OPERATOR'S MANUAL MOUNT, SMOKE GENERATOR, M2 AND MOUNT, FOG OIL DRUM, M3

Change }
No. 1 }

HEADQUARTERS
DEPARTMENT OF THE ARMY
Washington, D. C., 24 August 1973

TM 3-1040-255-10, 29 May 1969, is changed as follows:

Figure 1. M2 smoke generator mount.

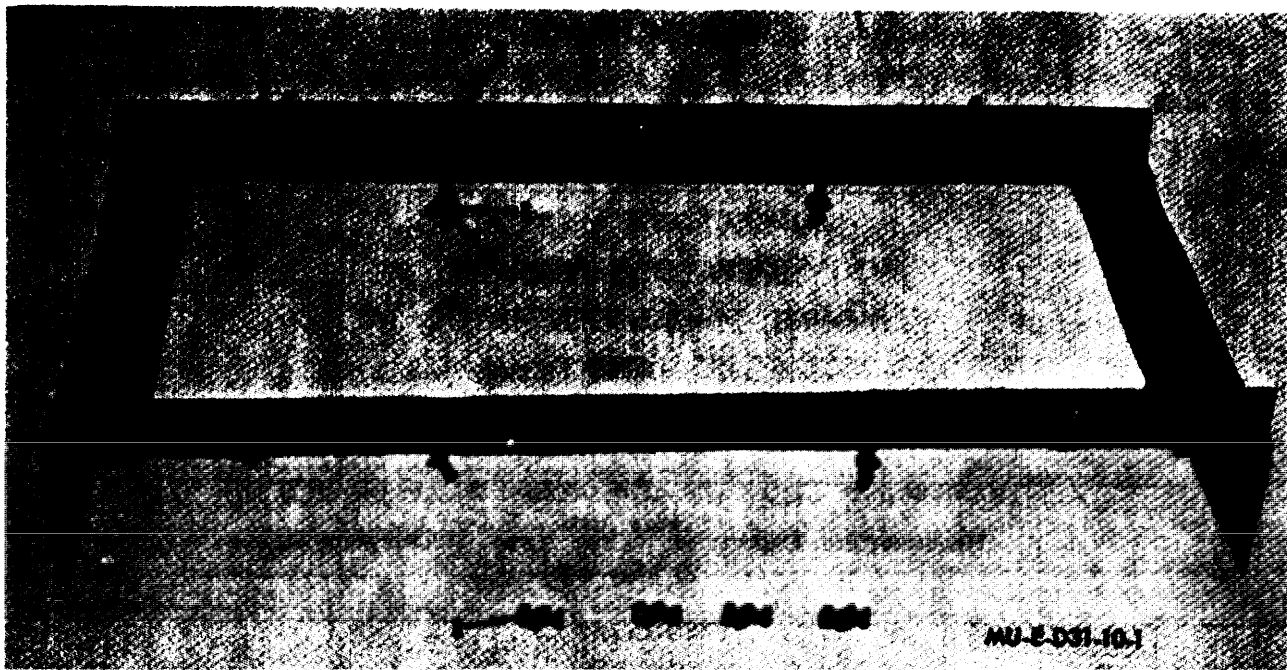
Page 3. Paragraph 4b is superseded as follows:

b. *M2 Smoke Generator Mount.* The M2 smoke generator mount consists of a frame assembly, four hook bolts, and four spacers. The frame assembly is made up of four angles bolted together at the corners. A hook bolt assembly (5, fig. 1) consists of a bent bolt, split metal tubing welded to the inside of the hook, and attaching hardware. A spacer (2) consists of a capscREW, bushing, lockwasher, and nut. Two hook bolts are attached to each side angle (4) and secure the smoke generator to the M2 mount. Two spacers are attached to each end angle (1) and are used to help position the smoke generator on the mount. The M2 mount is approximately 37½ inches long and 17½ inches wide, and 7 inches high when not expanded.

Latest versions of the M2 smoke generator mount do not have spacers (2, fig. 1) or holes for their installation.

Page 3. Add the following note between paragraph 6a(1) and 6a(2).

The following step (2) is omitted for latest versions of the M2 smoke generator mounts which do not have spacers.
